SECTION 4.55(1A) MODIFICATION APPLICATION STAGE 1B BASEMENT – ONE SYDNEY HARBOUR, BARANGAROO SOUTH

This modification application has been prepared by Ethos Urban on behalf of Lendlease (Millers Point) Pty Ltd, pursuant to section 4.55(1A) of the *Environmental Planning and Assessment Act 1979* (EP&A Act) to modify Development Consent SSD 6960 relating to the Stage 1B Basement at One Sydney Harbour, Barangaroo South (the site).

Figure 1 Proposed GFA reallocation on Basement Level B0

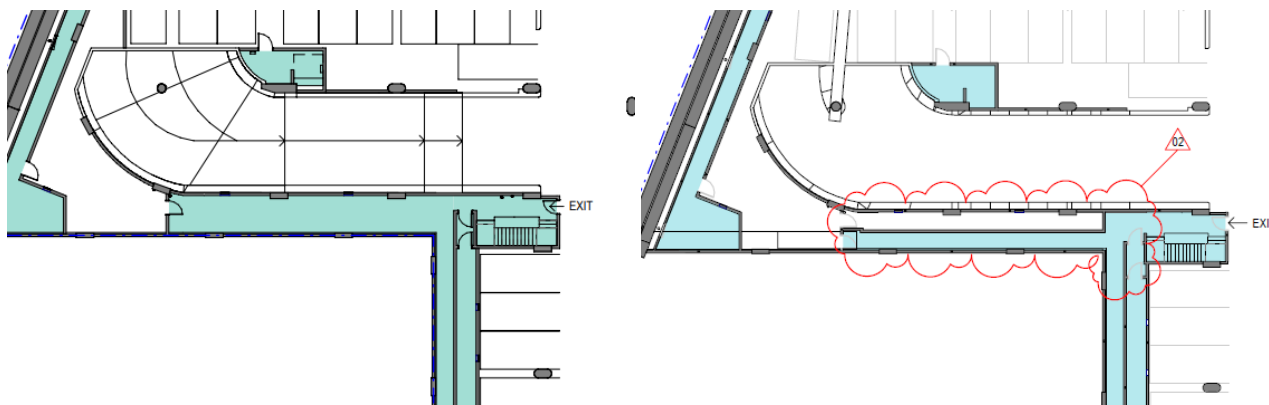
As shown at **Figure 1**, previously residential GFA (shown in yellow) is proposed to be reallocated as non-residential other uses GFA (shown in purple). A similar reallocation also occurs on Basement Level B1.

Approved basement layout (yellow indicating residential GFA)
residential other uses)

Proposed basement layout (blue indicating basement GFA – non-
